B.1 C-07 DRAWINGS AND PHOTOS (6 pages)

Submittal Information Covering

Cast Iron Flap Valve

ALLEGHENY COUNTY SANITARY AUTHORITY REGIONAL CONVEYANCE SYSTEM 2020 FLAP GATE REPLACEMENT PROJECT AT VARIOUS LOCATIONS

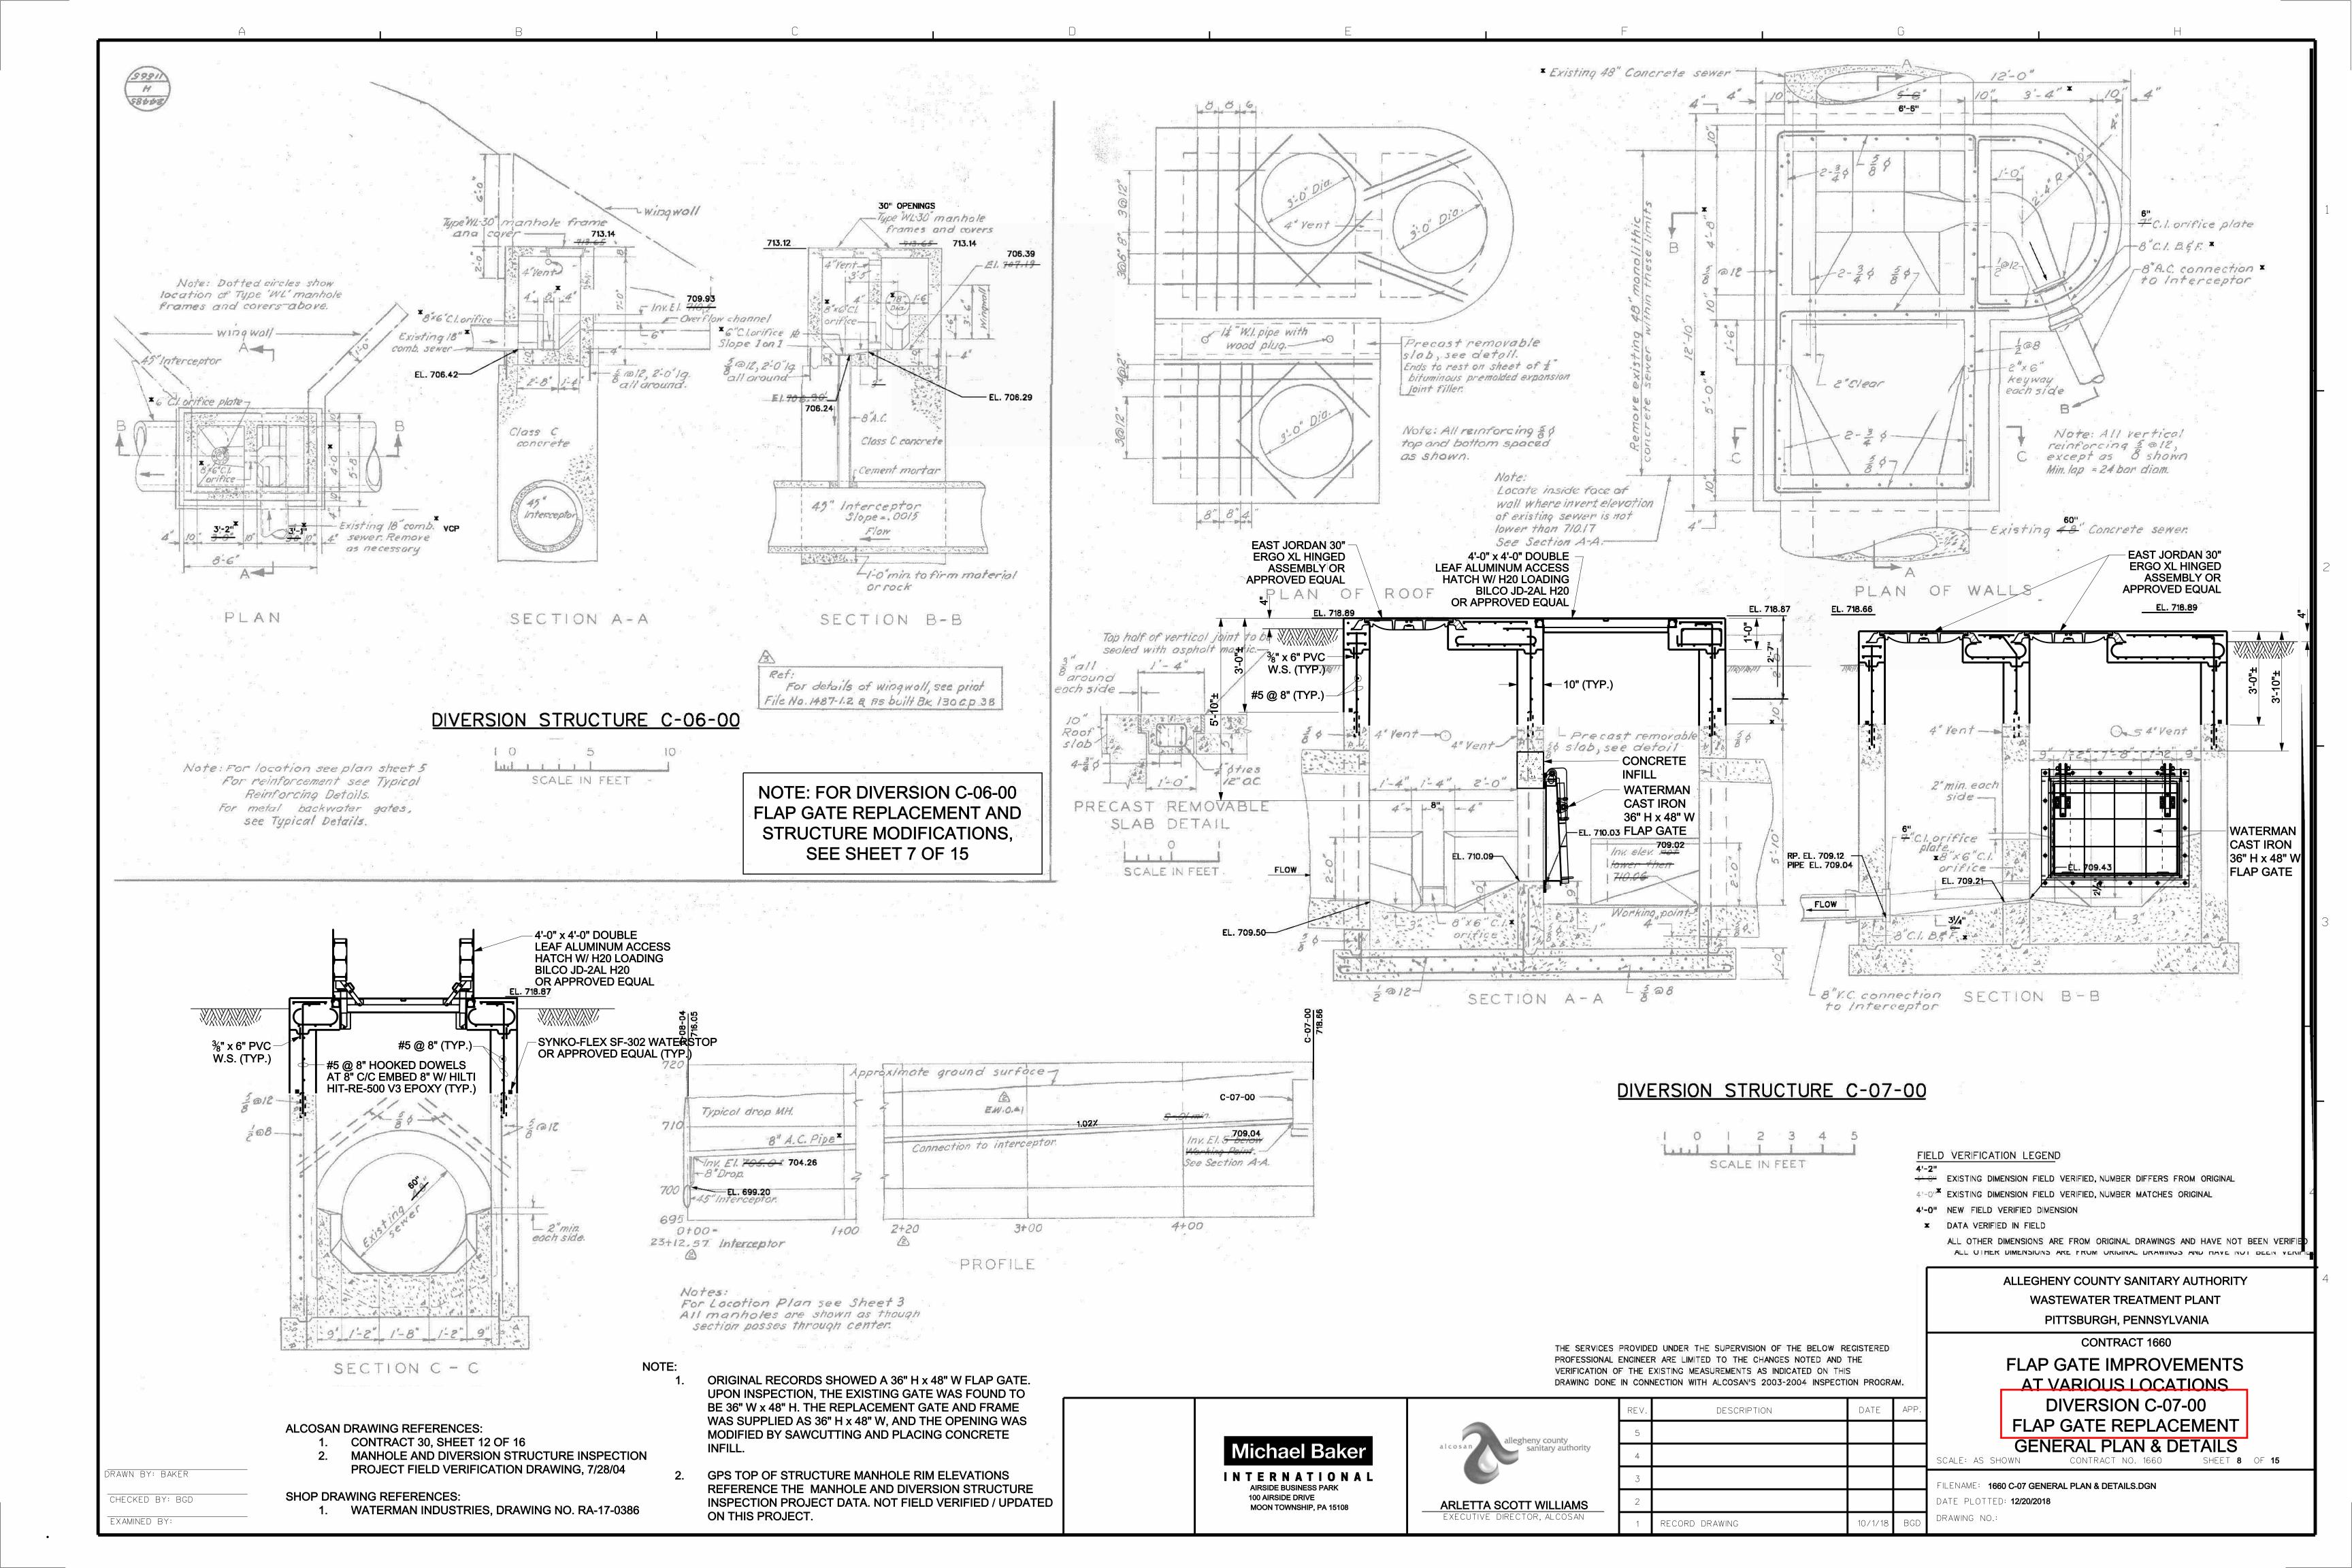
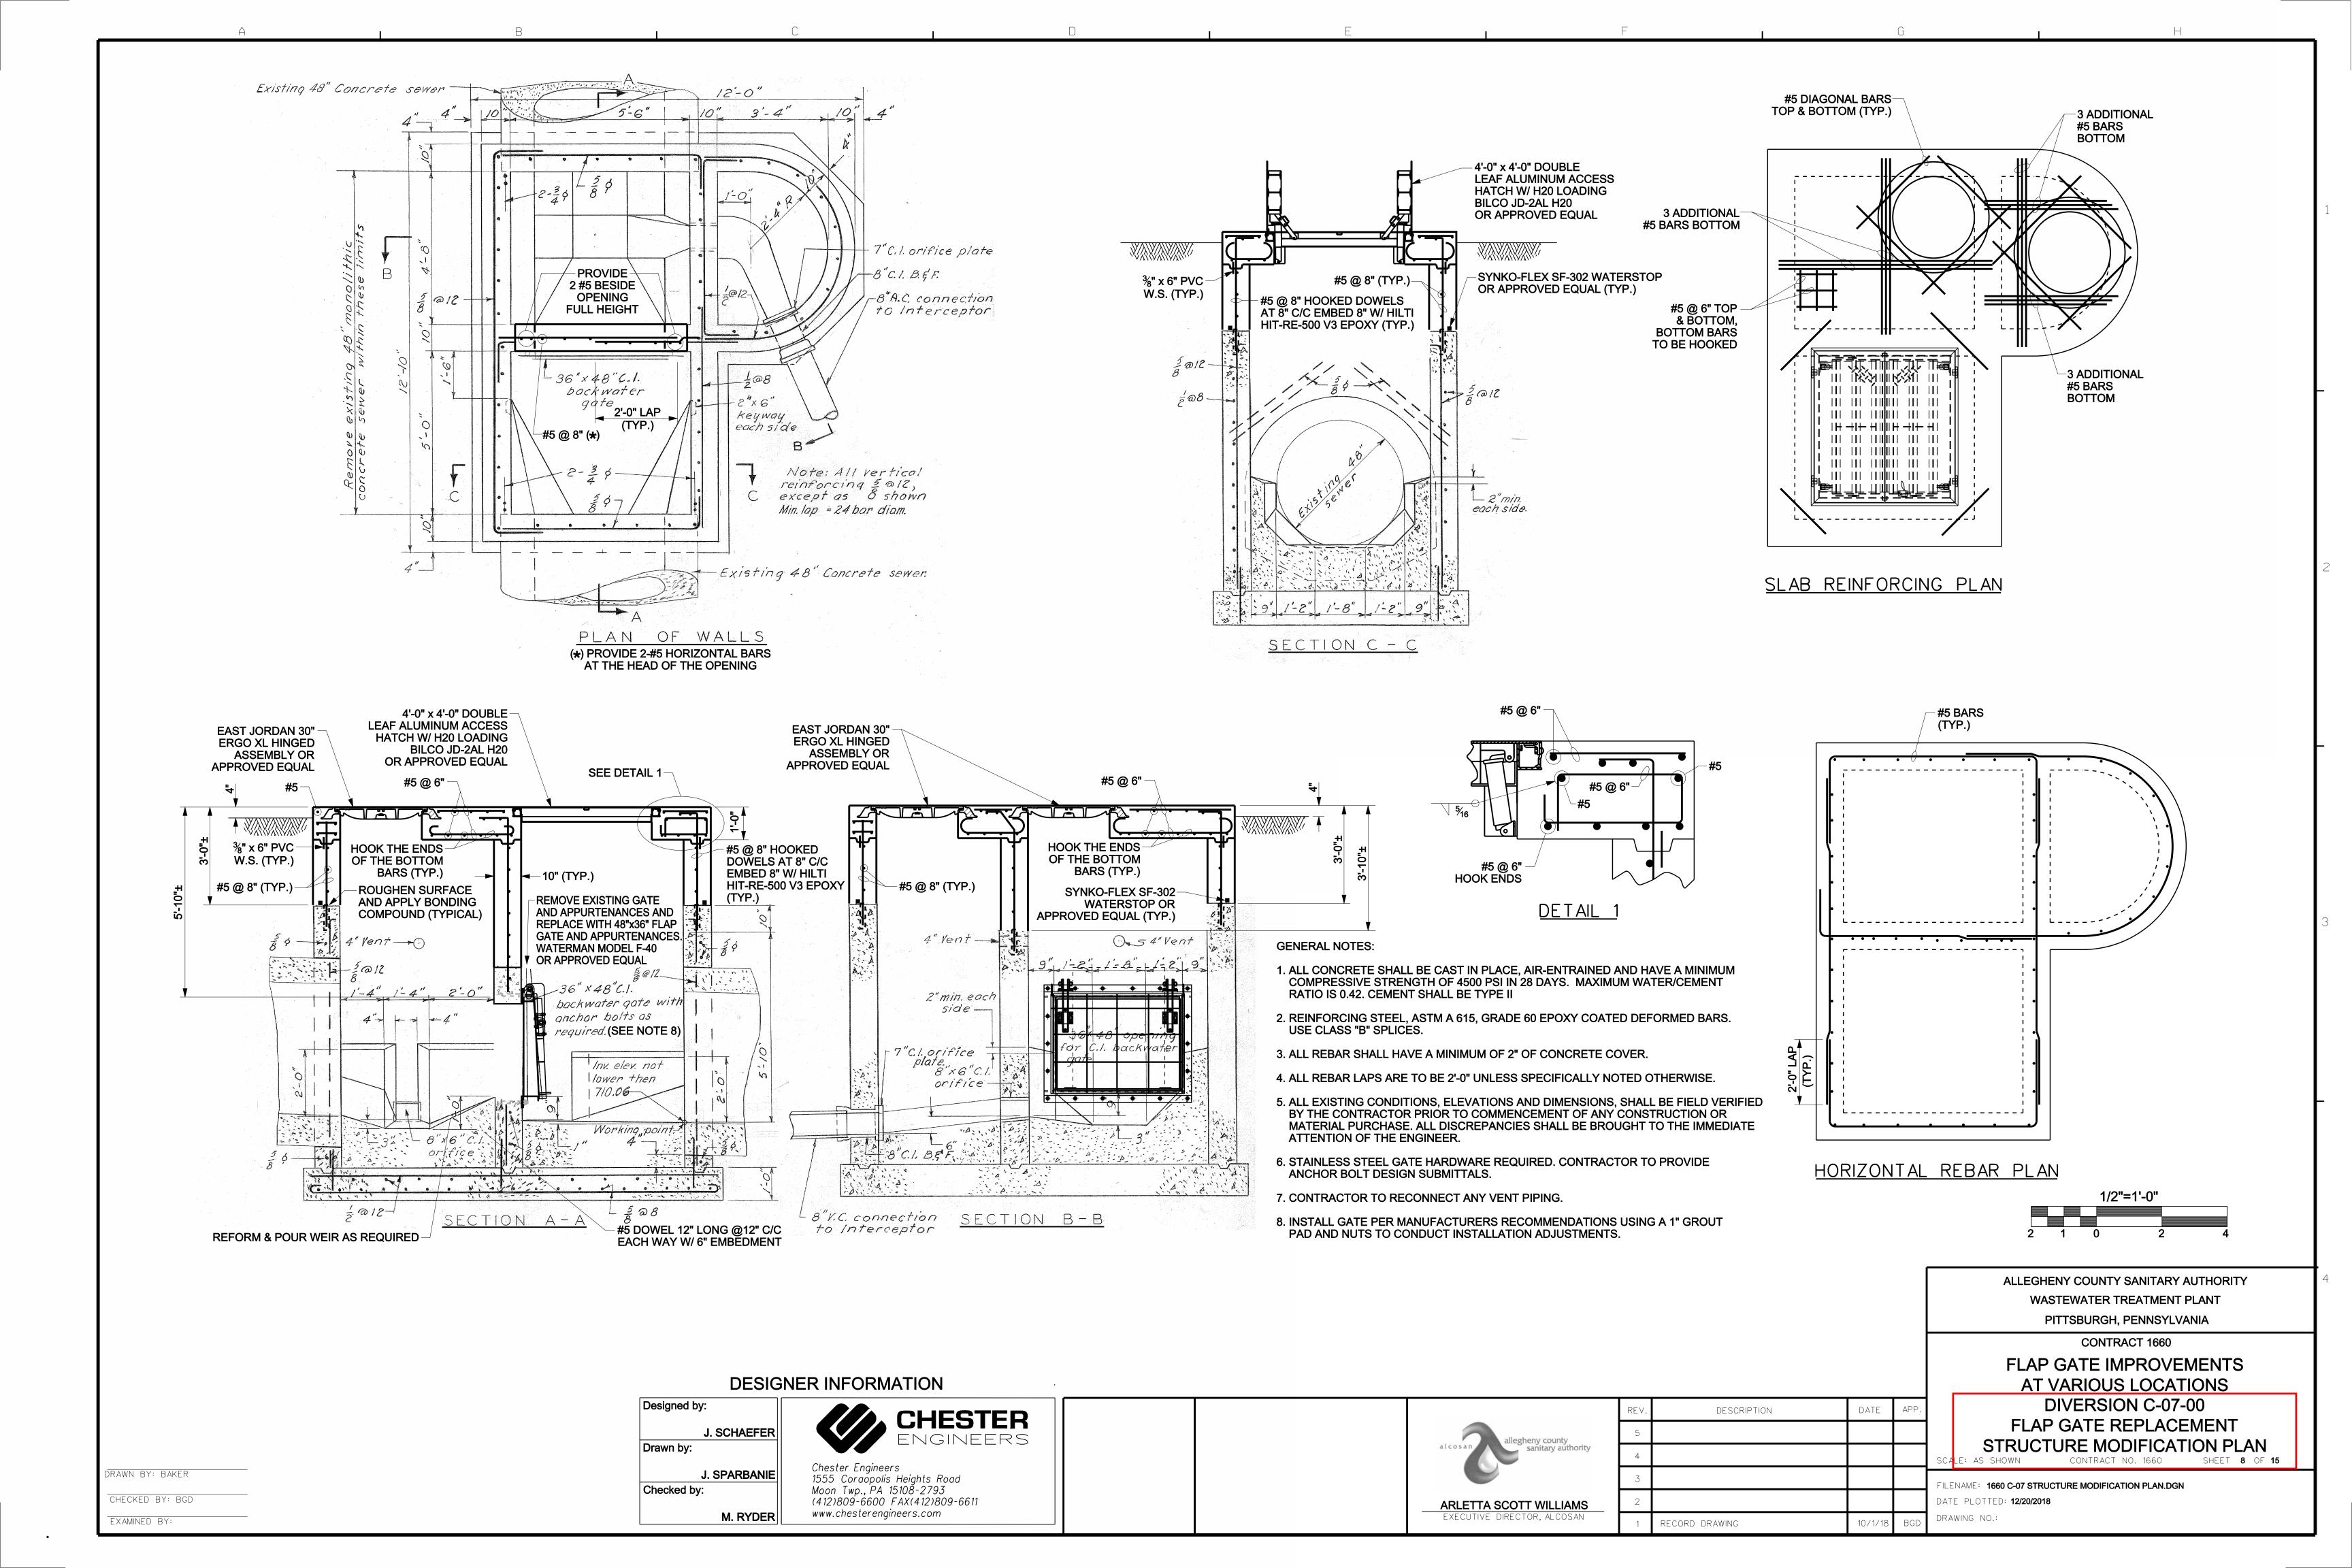
Manufacture: Waterm	nan	
Type/Model:	F-40	F-20
Size:	48x36	18x18
Provide or Confirm	48x36 at C-07-00	18x18 at M-53-00
Invert elevation	710.89 +/-	
Top of wall elevation	715.89 +/-	
Seating Head:	7.8'	
Unseating Head:	0.25'	
Wall Thickness:	10"
